BRYANT FIELD AIRPORT
BRIDGEPORT, CALIFORNIA

AIP NO. 3-06-0030-10-2016

REALIGNMENT OF STOCK DRIVE

ADDENDUM #2 - APRIL 26, 2016

CONSTRUCTION SAFETY AND PHASING PLAN

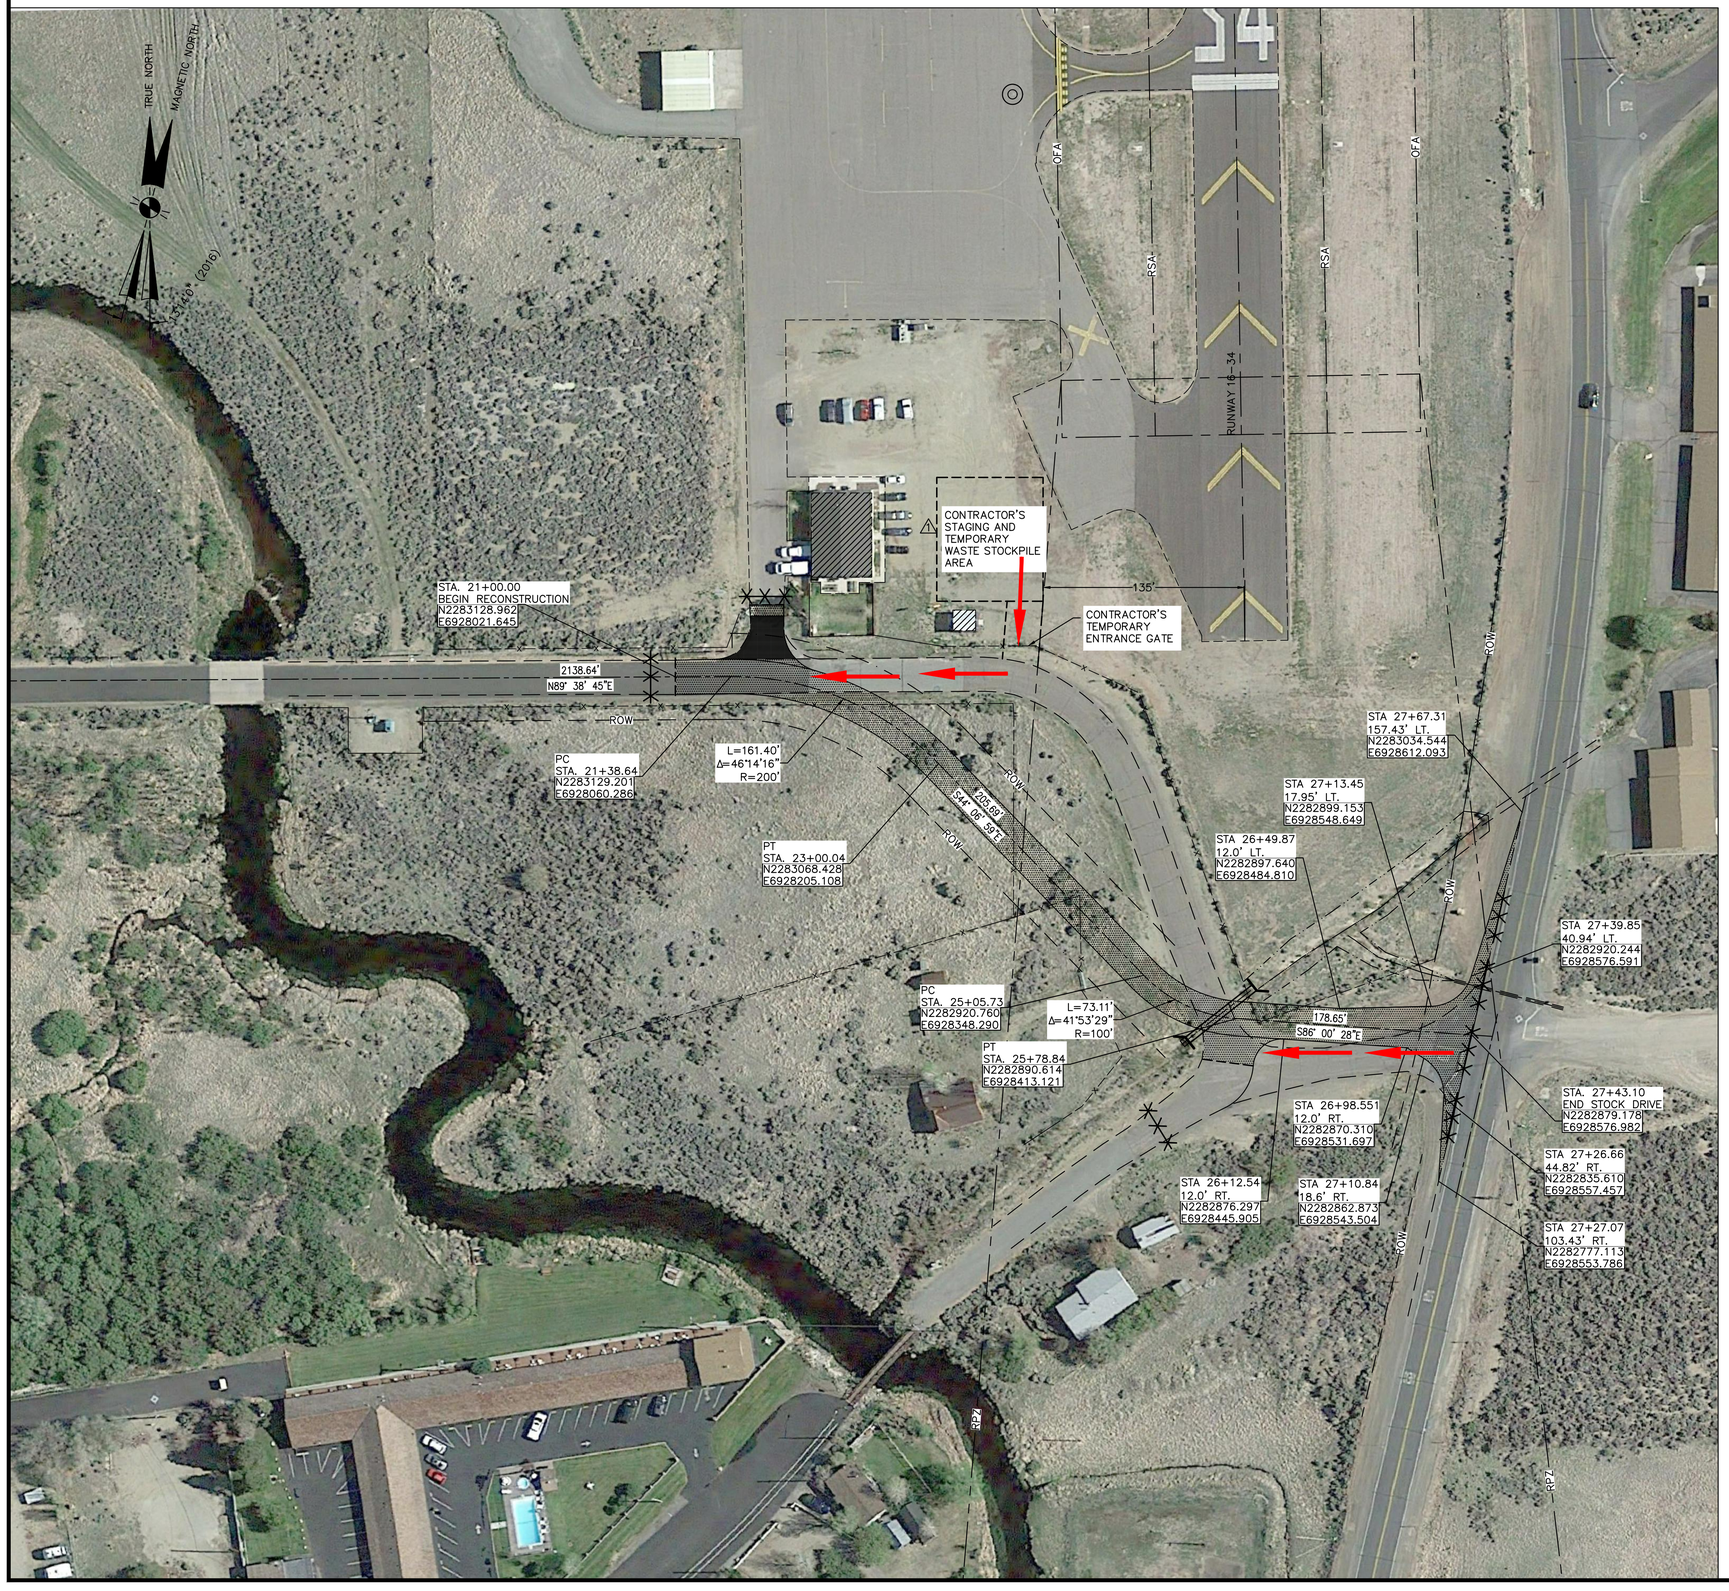
3. CONTRACTOR SHALL PROVIDE A DETAIL BARRICADE PLAN IN ACCORDANCE WITH MONO COUNTY STANDARDS AND CALTRANS PRIOR TO START OF ANY WORK.
4. △1 ACCESS TO AND FROM THE AIRPORT ON A CONTROLLED BASIS SHALL BE COORDINATED WITH THE AIRPORT MANAGER, RESIDENT ENGINEER AND CONTRACTOR. CONTRACTOR SHALL INSTALL AND MAINTAIN THE NECESSARY RAMPS IN ORDER TO PROVIDE ACCESS TO THE AIRPORT ENTRANCE. CLOSURE OF THE ENTRANCE FOR AC REMOVAL, EXCAVATION AND PLACEMENT OF NEW SECTION SHALL BE COORDINATED WITH RESIDENT ENGINEER AND POSTED ON THE NECESSARY SIGNAGE AS REQUIRED BY MONO COUNTY PUBLIC WORKS. ACCESS RAMPS SHALL BE IN PLACE AT THE END OF EACH WORKING DAY.

CONSTRUCTION LAYOUT PLAN

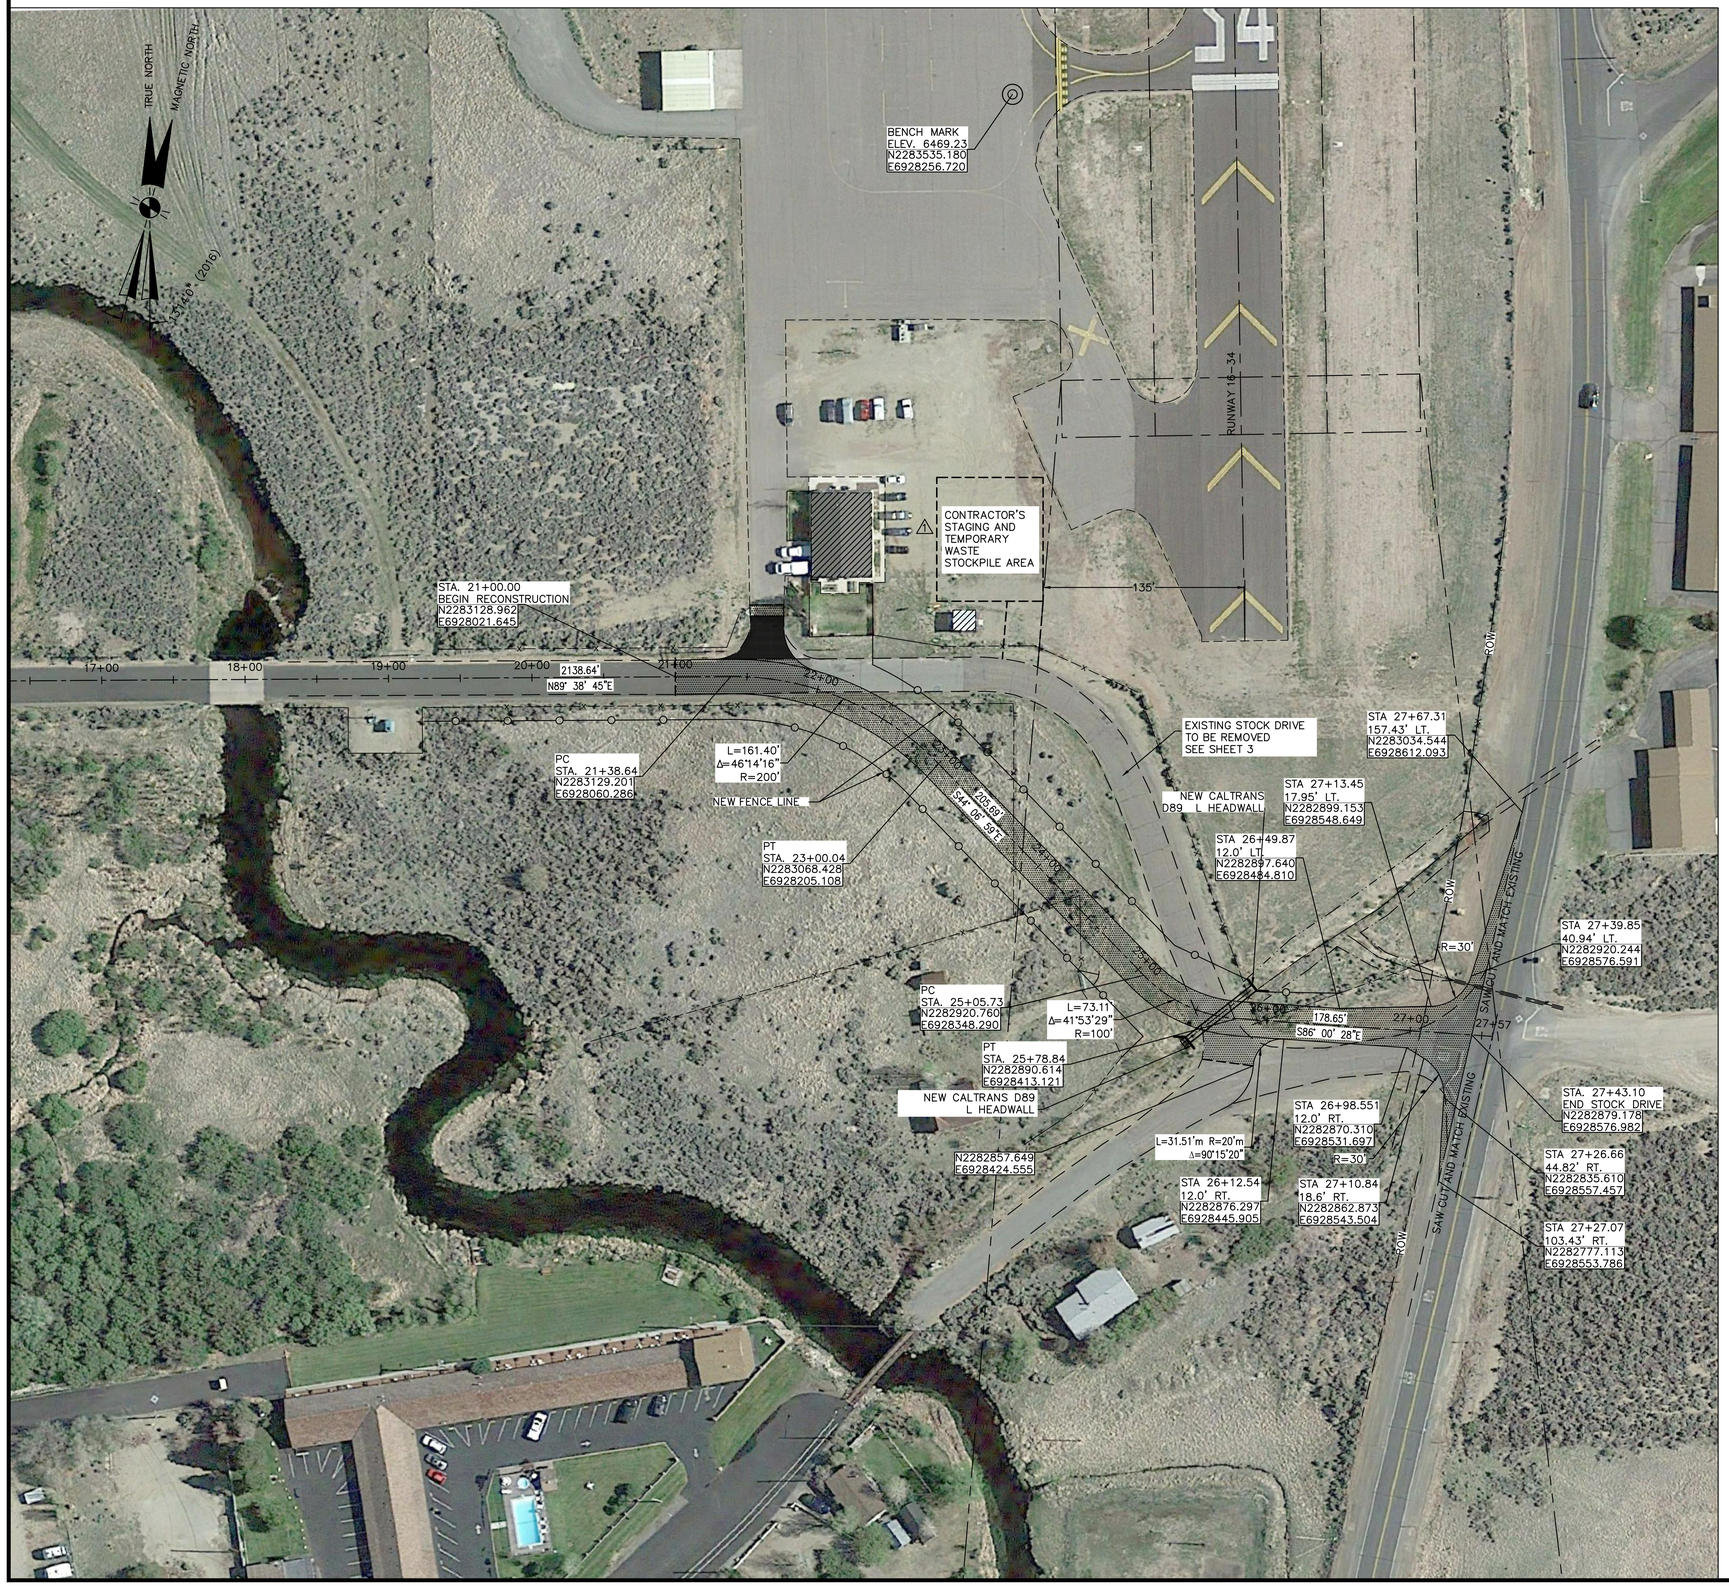
△1 ADD TEMPORARY WASTE DISPOSAL AREA
ADD STATION AND OFFSET TO STATE GRID COORDINATES

GRADING PLAN

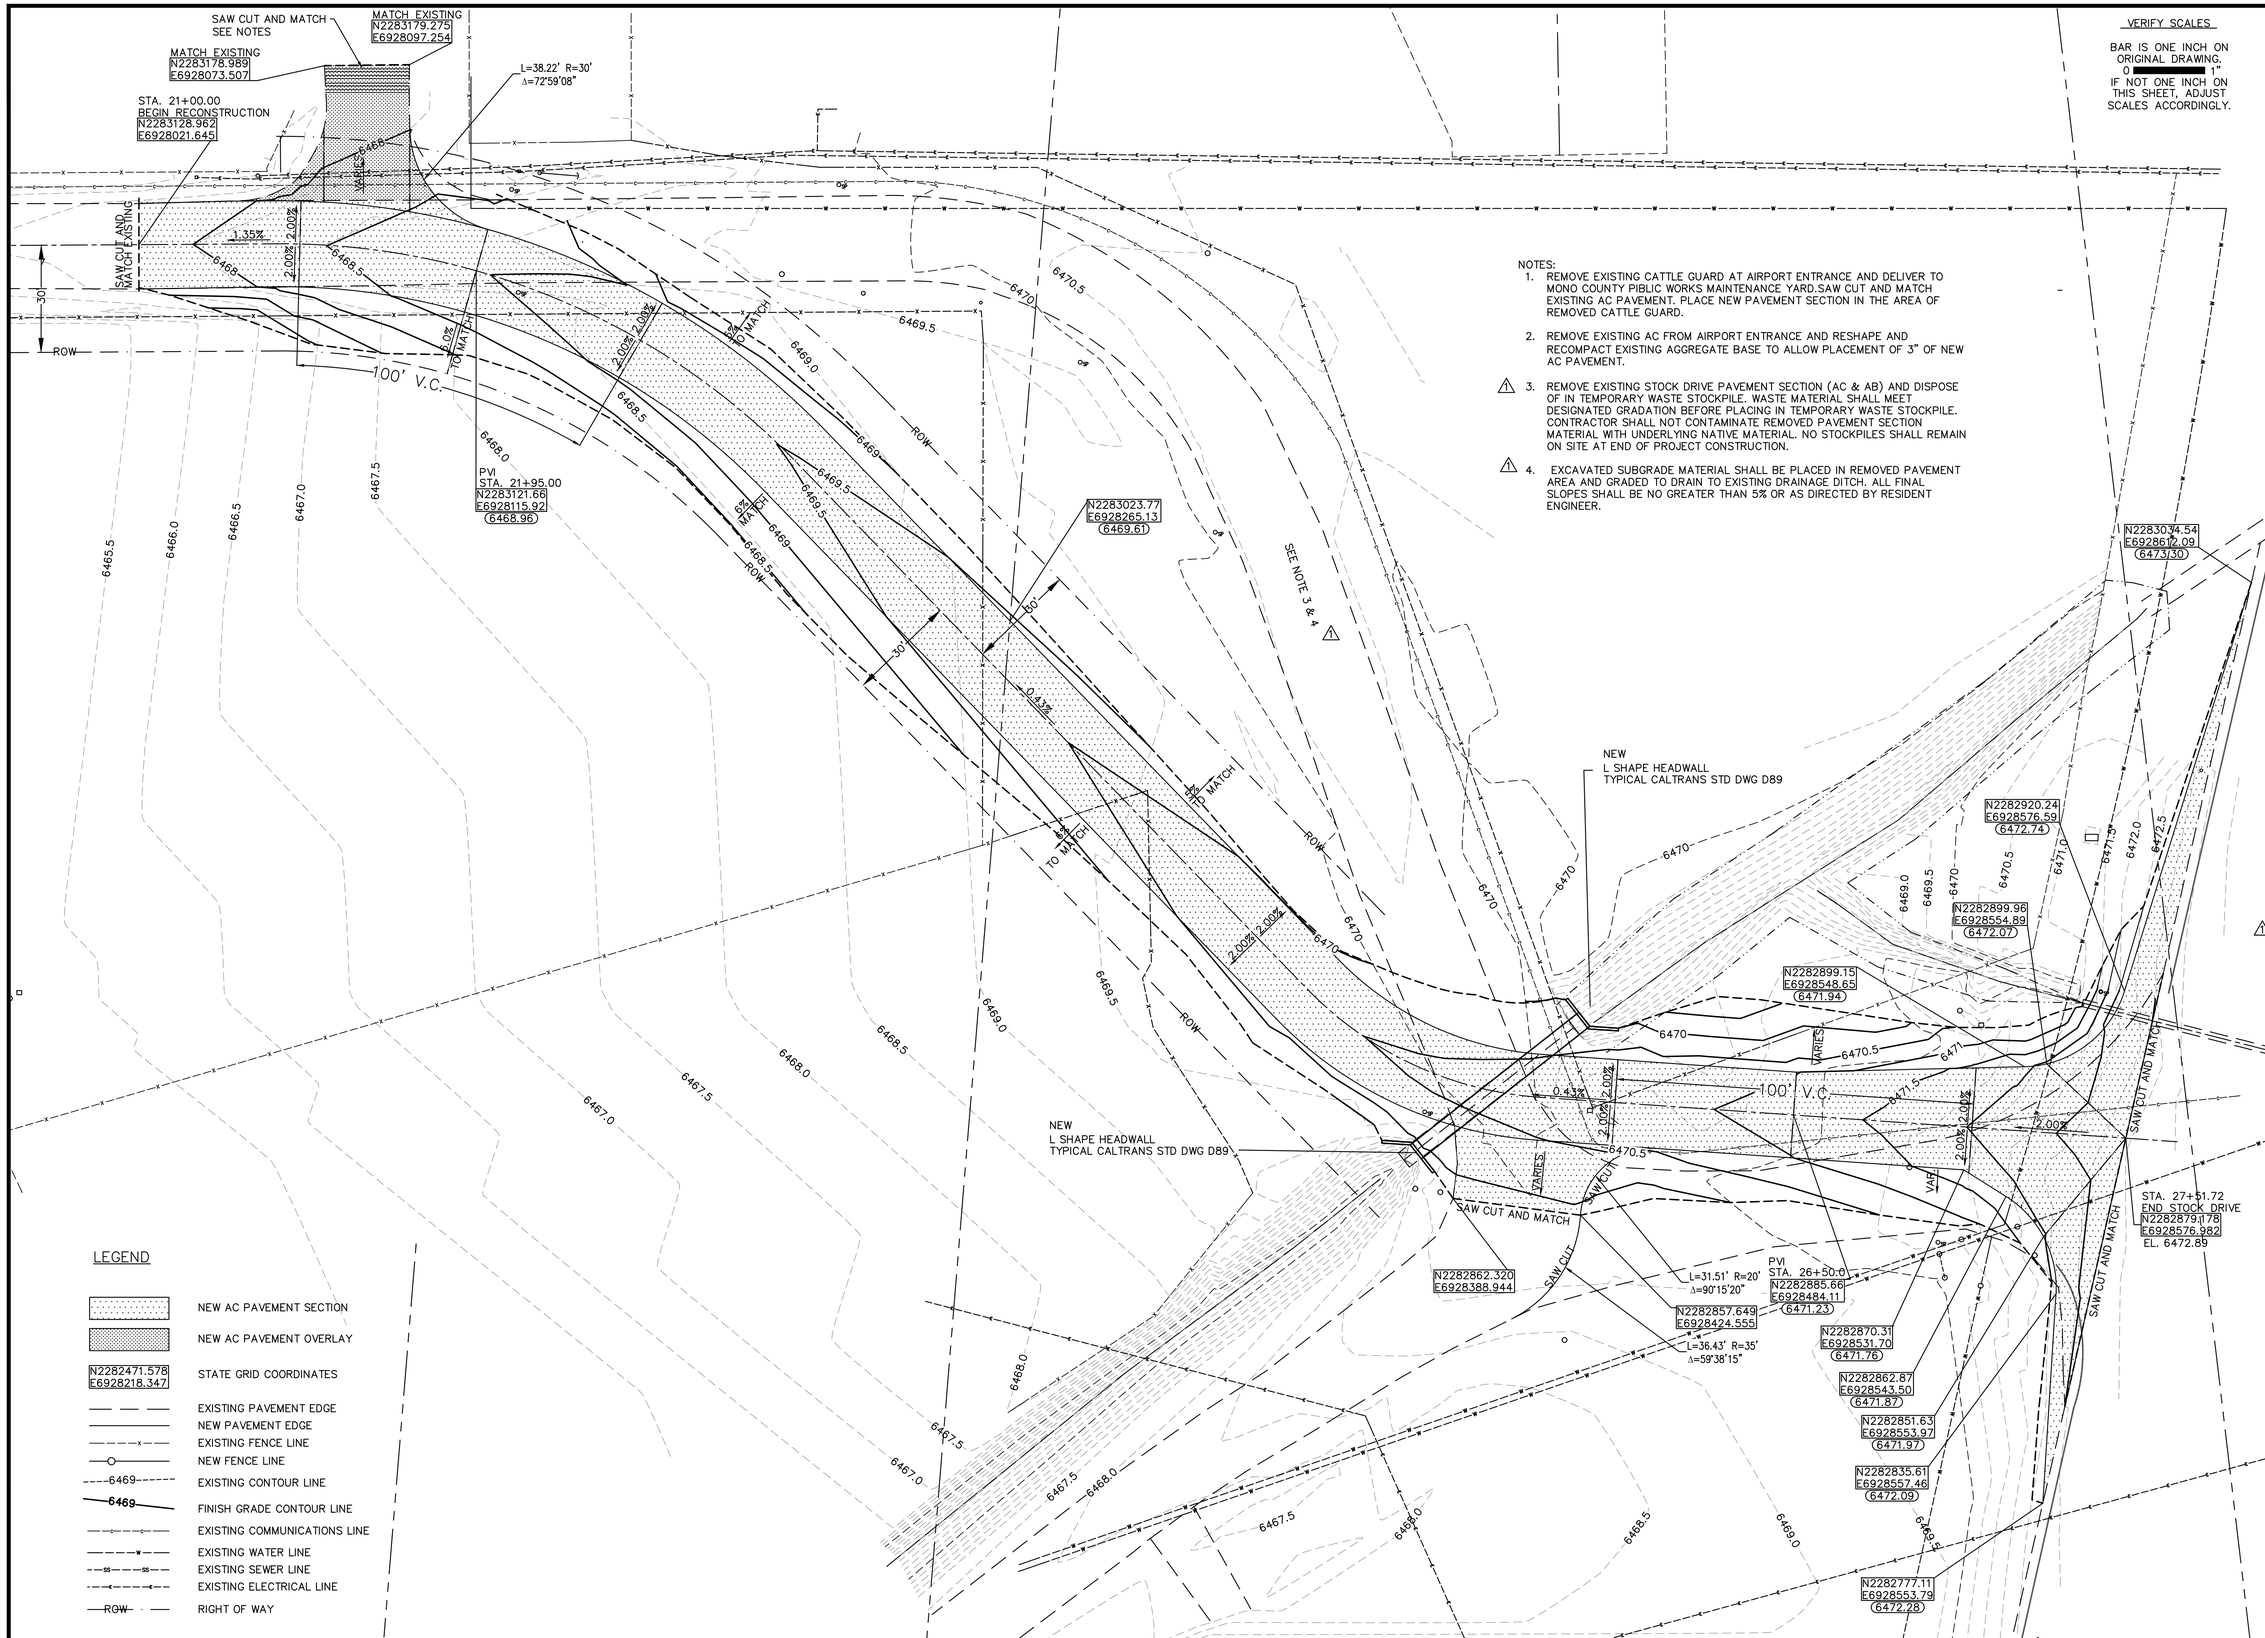
2. REMOVE EXISTING AC FROM AIRPORT ENTRANCE AND RESHAPE AND RECOMPACT EXISTING AGGREGATE BASE TO ALLOW PLACEMENT OF 3" OF NEW AC PAVEMENT.
3. (1) REMOVE EXISTING STOCK DRIVE PAVEMENT SECTION (AC & AB) AND DISPOSE OF IN TEMPORARY WASTE STOCKPILE. WASTE MATERIAL SHALL MEET DESIGNATED GRADATION BEFORE PLACING IN TEMPORARY WASTE STOCKPILE. CONTRACTOR SHALL NOT CONTAMINATE REMOVED PAVEMENT SECTION MATERIAL WITH UNDERLYING NATIVE MATERIAL. NO STOCKPILES SHALL REMAIN ON SITE AT END OF PROJECT CONSTRUCTION.

4. (1) EXCAVATED SUBGRADE MATERIAL SHALL BE PLACED IN REMOVED PAVEMENT AREA AND GRADED TO DRAIN TO EXISTING DRAINAGE DITCH. ALL FINAL SLOPES SHALL BE NO GREATER THAN 5% OR AS DIRECTED BY RESIDENT ENGINEER.

42" x 60" PIPE CROSSING - PLAN AND PROFILE

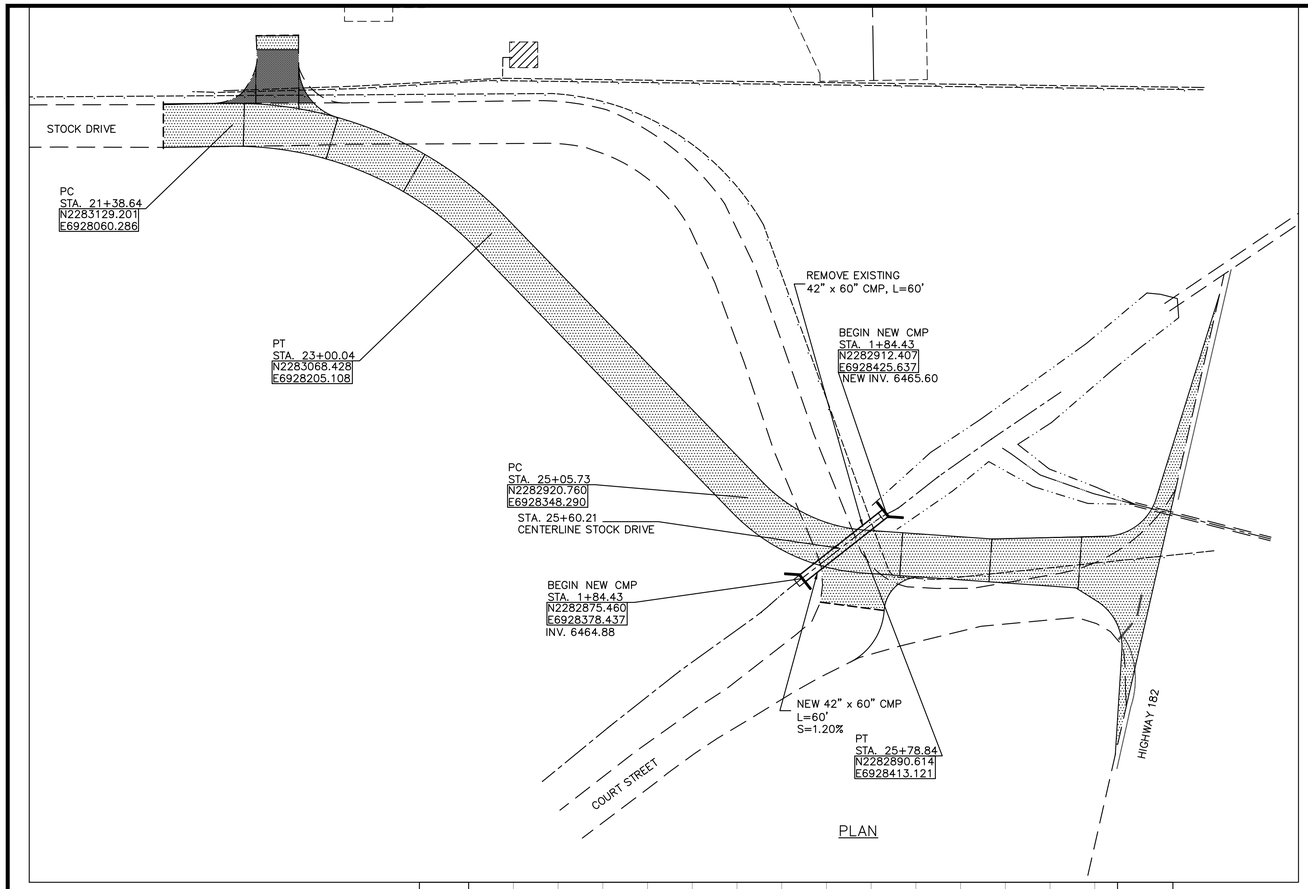
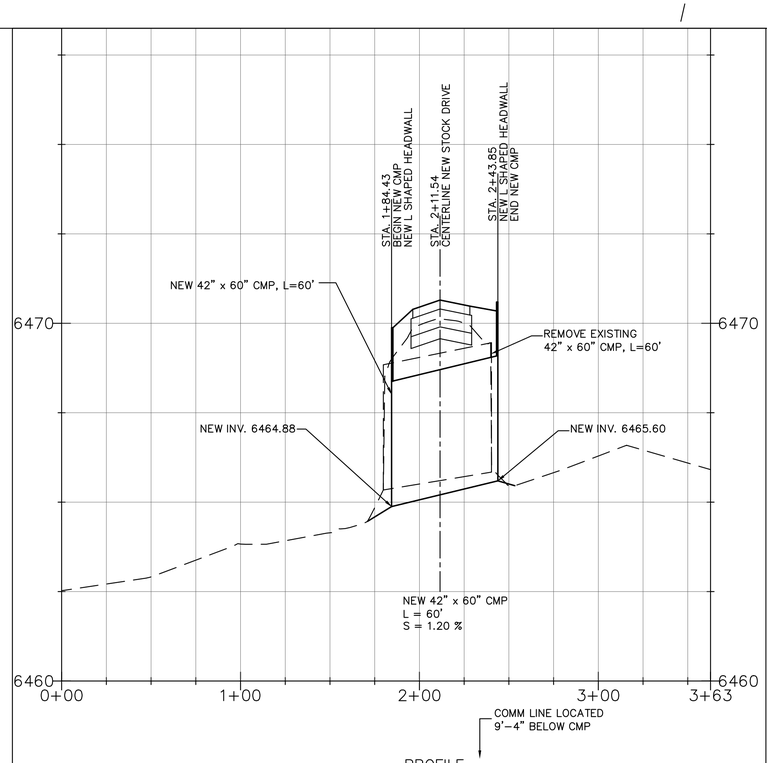
1. EXISTING 42" x 60" CMP SHALL BE REMOVED AND DELIVERED TO MONO COUNTY PUBLIC WORKS MAINTENANCE DEPARTMENT YARD.
2. △1 EXISTING WILLOWS ARE LOCATED IN THE EXISTING DRAINAGE SWALE AT THE ENDS OF THE EXISTING DRAINAGE PIPE. WILLOWS, LOCATED IN THE AREA TO BE DISTURBED BY THE CONSTRUCTION AND PLACEMENT OF THE NEW CMP PIPE AND HEADWALLS, SHALL BE REMOVED BY THE CONTRACTOR AND PROTECTED FROM DAMAGE. CONTRACTOR SHALL STORE WILLOWS IN A WET ENVIRONMENT AND REPLANT WILLOWS AFTER NEW CMP DRAINAGE PIPE AND HEADWALLS ARE INSTALLED.
3. NEW L SHAPED HEADWALL SHALL CONFORM TO CALTRANS STANDARD DRAWING D89.
